Service Instruction SI-0023

Subject: Firewall Blanket Patch

ATA-Code: 71-30

Labor: 3.0 Hours	**Effectivity:** K018
Affected Model(s): E1000	**Due:** Next scheduled maintenance event.
Compliance: Mandatory	**Recurrence:** No

Figure 1: Firewall Blanket Patch

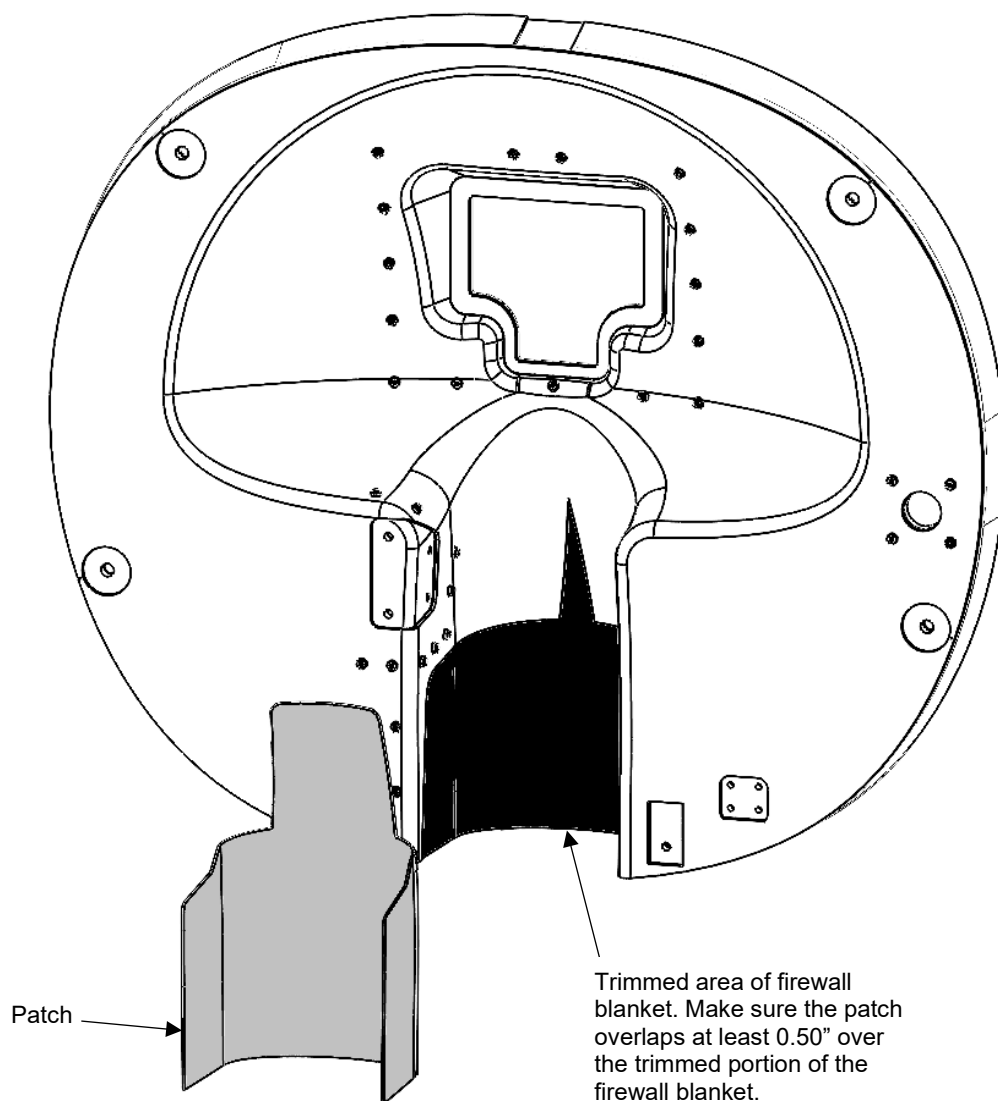
While complying with SB-0028, extra firewall blanket material was inadvertently removed at the lower edge of the firewall blanket in the nose landing gear well.

Trimmed area of firewall blanket. Make sure the patch overlaps at least 0.50" over the trimmed portion of the firewall blanket.

NOTE: Do a dry run to check fit the patch before using sealant to position it on the firewall blanket. Make sure there is a 0.50" overlap around the trimmed area of the firewall blanket.

4. Use PR-1995 on the patch and firewall to secure the firewall blanket patch in position.

5. Make sure the patch has a 0.50" overlap with the firewall blanket and is flush with bottom surface of fuselage. Trim the firewall blanket with a razor blade as needed.

NOTE: The blanket must be flush with the fuselage skin.

6. Seal the trimmed edge of the blanket using PR-1995 Class B firewall sealant.
